Case Number: R18065

R18065

Existing Stormwater Asset Map possibly affected by the Proposed Development

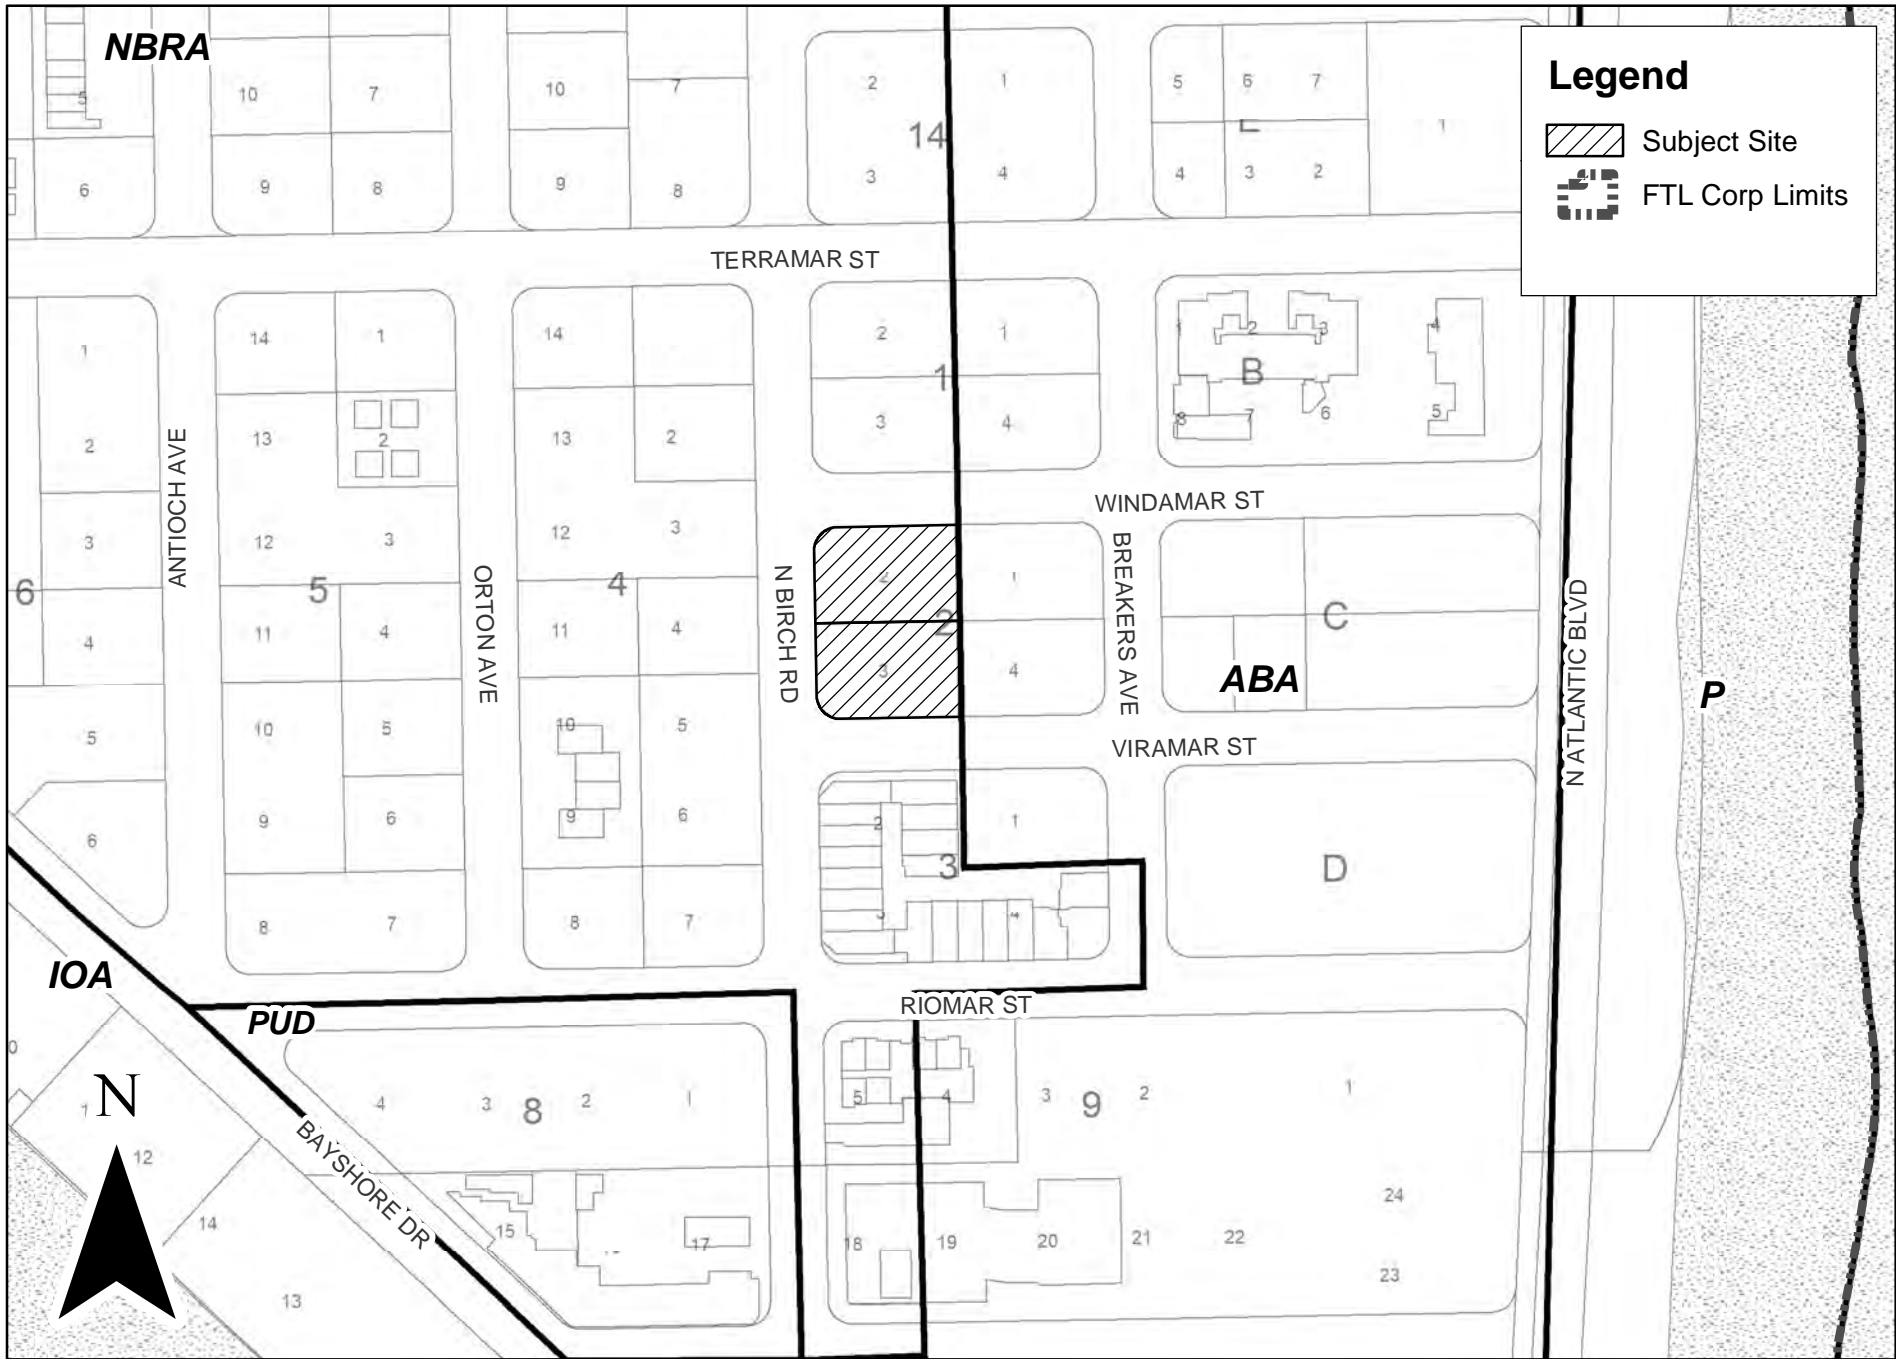
The City owns and maintains stormwater infrastructure adjacent to the proposed development as shown with green line work in the map provided at the end of this report. **Civil plans shall show the City's stormwater inlet ID #s as identified in the map provided at the end of this report.** The following comments pertain to possible impacts of the proposed development and/or construction activities to the existing condition of the City's stormwater assets. The applicant shall provide an itemized response letter addressing the following comments:

1. Please provide (or revise if already submitted) an erosion, sedimentation, and stormwater pollution prevention plan (**SWPPP**) showing the adjacent City's existing stormwater system as shown in the survey and to the limits shown with green line work in the storm map provided at the end of this report. A copy of the approved SWPP shall be at the construction site from the date of demolition initiation to the date of final construction activities.

- a) Contractor shall provide CCTV videotapes to City STW OPS of the existing stormwater system to the limits shown with green line work in the storm map provided at the end of this report in order to document the PRE and POST construction conditions of the City's storm system.
- b) Contractor shall provide the PRE construction CCTV to City STW OPS when applying for a demolition permit at the City's building department.
